Notice of Allowability

10/694,217

BAEK, HEUM-IL

FIG. 3

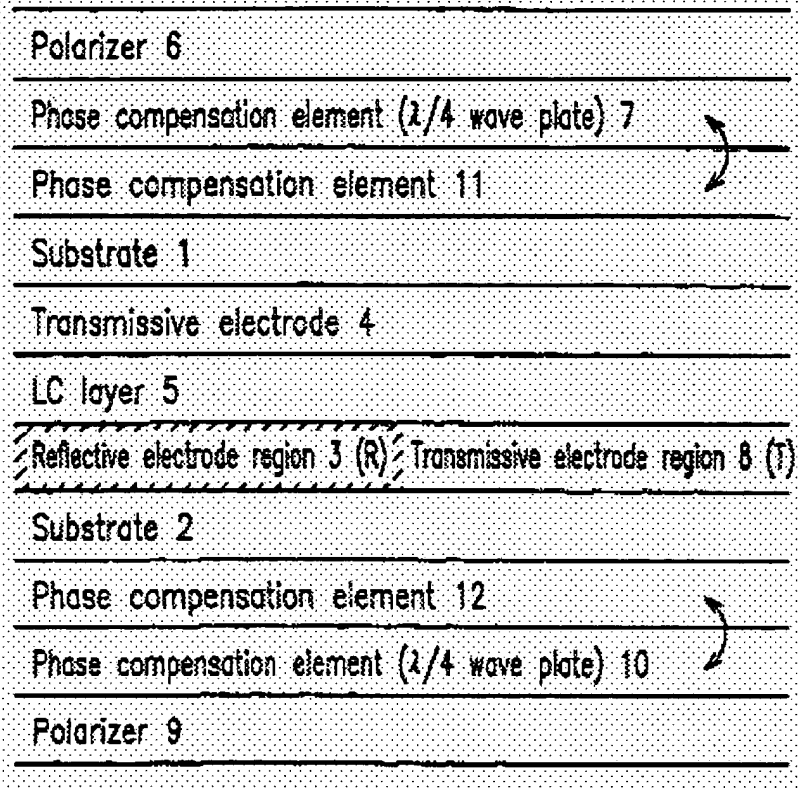
As to claims 1 and 29, relevant prior art of record, either alone or in combination, does not disclose nor render obvious a transflective liquid crystal display as claimed, wherein the first adjusted thickness is $d+d_{\text{sub.1}}$, where d is a normal thickness of the liquid crystal layer and $d_{\text{sub.1}}$ is calculated using the following equation,

The closest reference is Kubo who discloses in his description of the preferred embodiments (embodiment 1, col. 8, line 20 through col. 19, line 54, and especially second example, col. 19, line 55 through col. 24, line 55, as shown in Figures 8A and 8B), a transflective display similar to Applicant's species A, [Applicant's Figure 6] which is equivalent in most other regards to Examples 3 (regarding retarders applicable to Example 6) (col. 24, line 56 through col. 29, line 67) and 6 (regarding electrodes and other structure), (col. 47, line 50 through col. 51, line 25) a transmissive and reflective type (Applicant's transflective) (col. 8, lines 37-40) liquid crystal display, comprising:

substrate 1 (Applicant's upper) and substrate 2 (Applicant's lower), substrates facing into and spaced apart from each other, wherein the upper and lower substrates include a plurality of pixel regions (region R and region T) that display images;

FIG. 8A

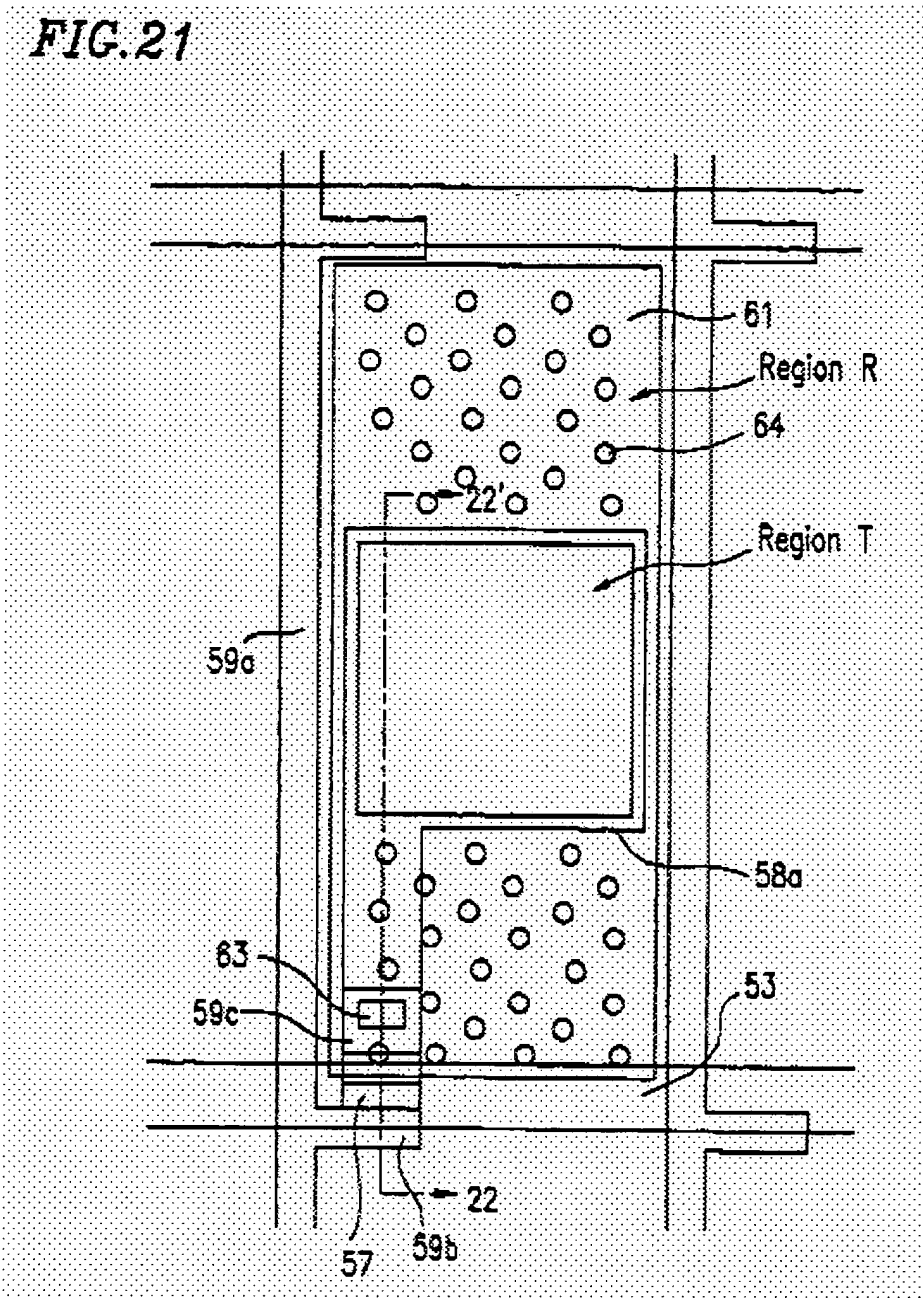
Structures in Figures 8A and 8B are largely similar to Figure 22 with exception of the removal of material in Region T:

a liquid crystal layer, 5, interposed between the upper and lower substrates, wherein the liquid crystal layer has a first adjusted thickness (region R) to compensate a residual optical retardation of incident light caused by anchored liquid crystals near an alignment layer when a maximum operation voltage is applied;

a first upper retardation film, 11, over the upper substrate;

a second upper retardation film, 7, between the first upper retardation film (interchangeable as indicated) and the upper substrate, wherein the second upper retardation film has a second adjusted thickness of compensating an optical retardation caused by the liquid crystal layer (col. 28, lines 32-53);

an upper polarizer, 6, on the first upper retardation film;

a transparent common electrode, 4, on a surface of the upper substrate facing into the lower substrate;

a pixel electrode over the lower substrate, wherein the pixel electrode corresponds to each pixel region, and the pixel electrode is divided into transparent, 58a, and reflective, 61, portions;

However, Kubo does not teach use of a first adjusted thickness limited as claimed.
